**Addendum No. 03.1****Issued: March 21, 2025**

Project Name: Brighton High School Teen Center  
Project No.: 2024516  
Bid Document Date: March 1, 2025  
Bid Package: NA  
Owner Name: Canyons School District

**E101**

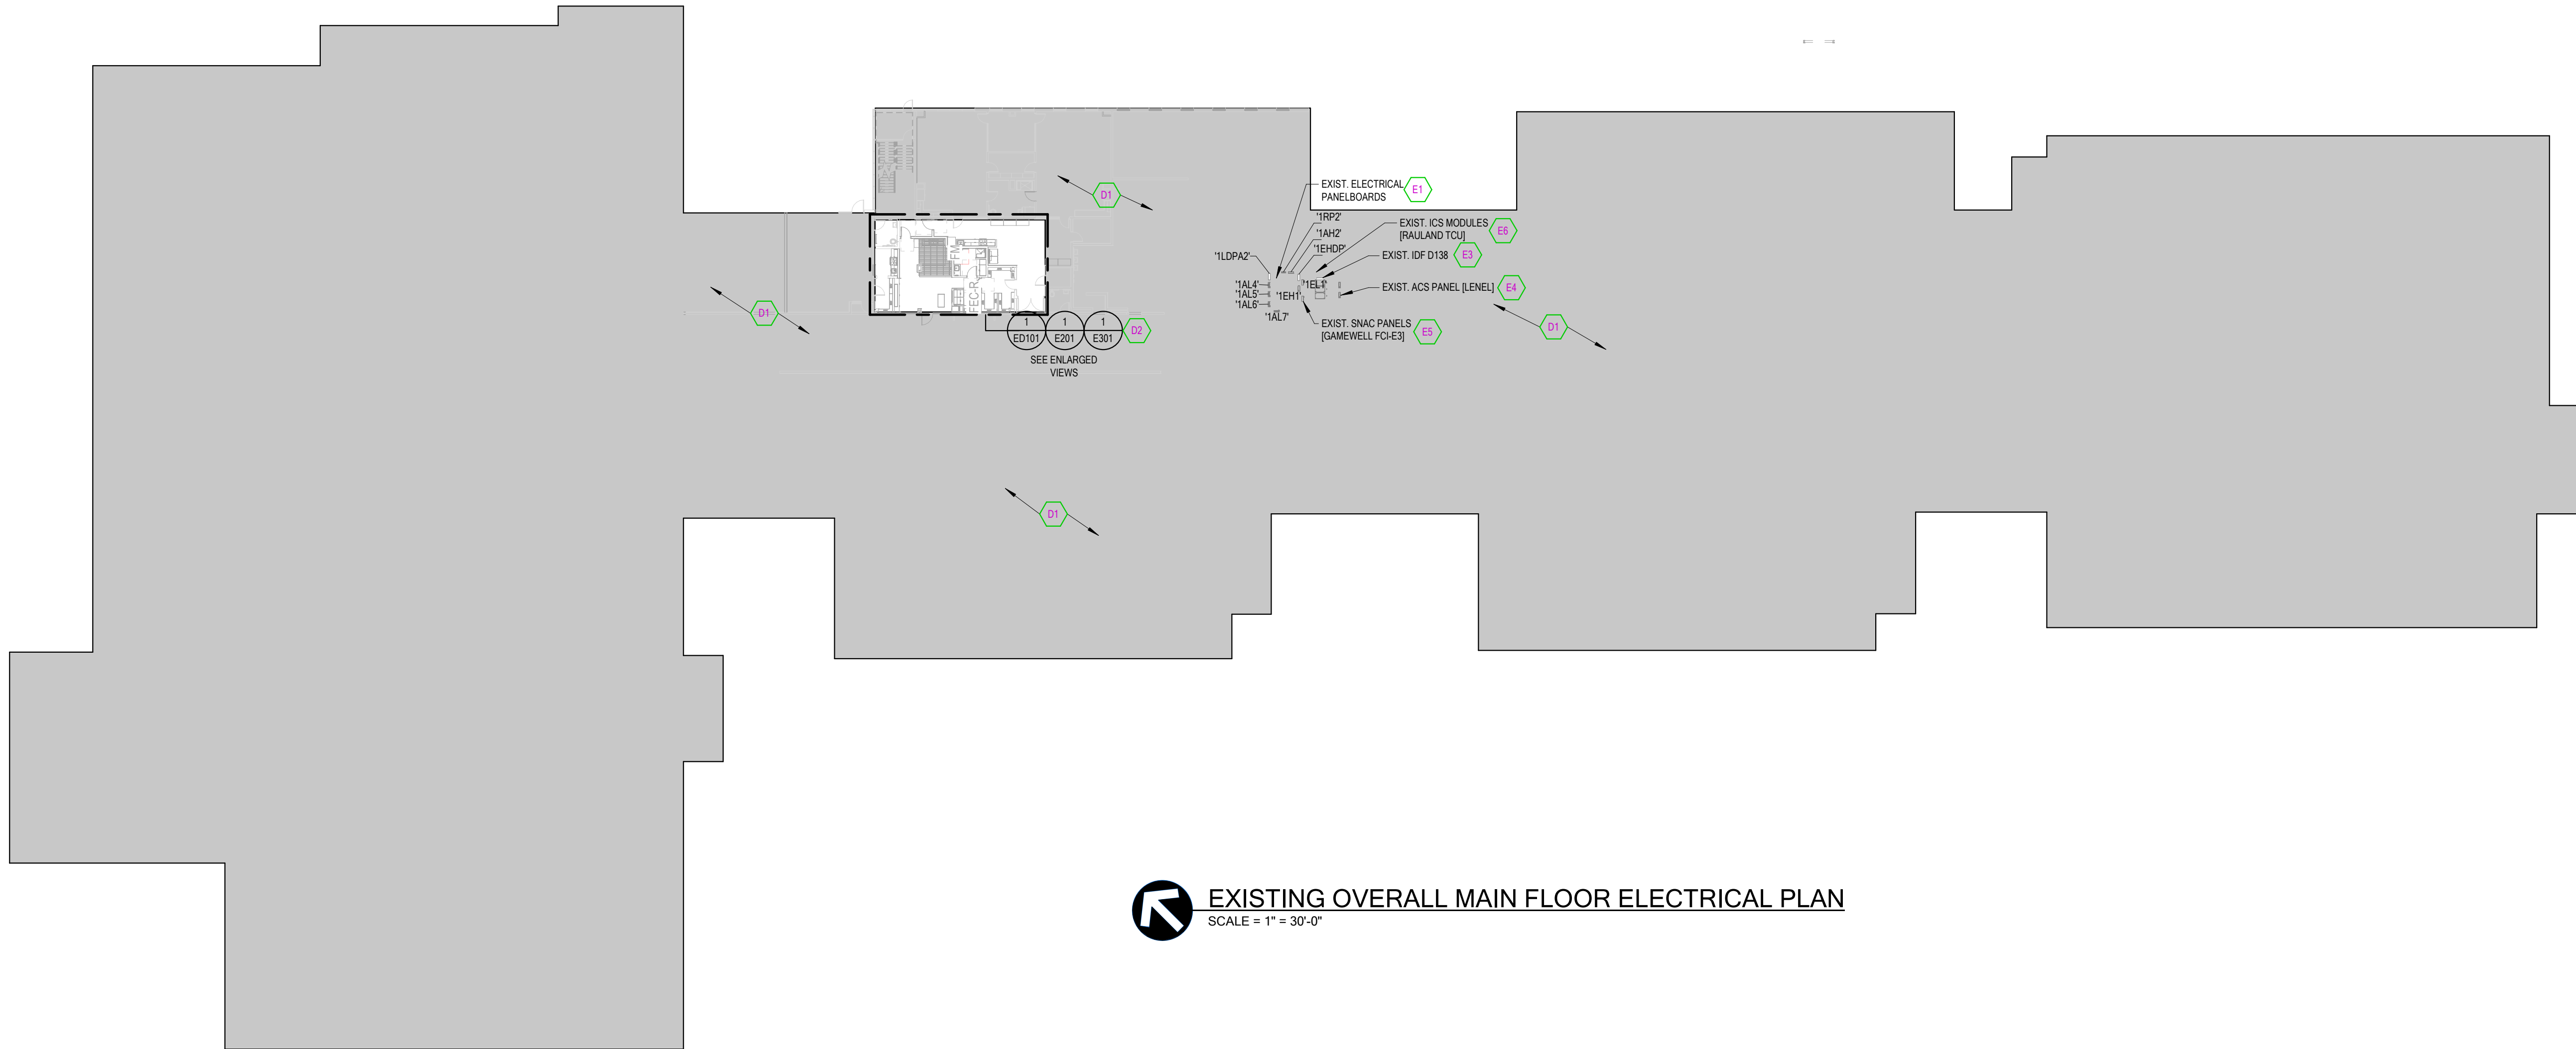
- Keynote E3 has been clarified.

- E3 EXISTING NETWORK RACK. REMOVE ANY DEMOLISHED NETWORK CIRCUITS BACK TO SOURCE. CONTRACTOR SHALL PROVIDE ALL NEW PATHWAYS, CABLING, NEW PATCH PANELS, LABEL, ETC. AS REQUIRED. SEE SPECS AND SEE E301 SHEET FOR NEW REQUIREMENTS.
